GROTE LIGHT BAR CHANGE NOTIFICATION

As part of Grote's commitment to continuous product improvement, we have implemented changes to our **LED Off-Road Light Bars**.

PRODUCT NUMBERS AFFECTED:

64J11-5 64J21-5 64J31-5

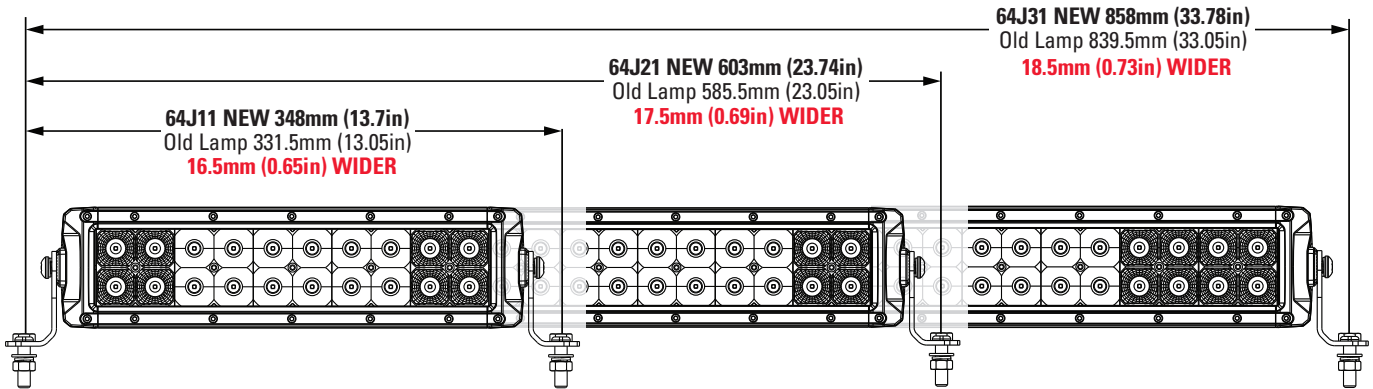
Grote's LED Off-Road Light Bars have increased in size. Please take note of new overall dimensions and mounting hole positioning. Additionally, Grote's LED Off-Road Light Bars now feature:

- 50% brighter output (64J11 = 5400 lumens, 64J21 = 10800 lumens, and 64J31 = 16200 lumens)
- The same or lower amperage draw as previous versions
- Dual mounting options (adjustable pedestal or side mount)
- An updated wiring harness with a DT Deutsch connector, illuminated switch, 40A relay, and total length of 8.25'
- Full color, retail-friendly packaging
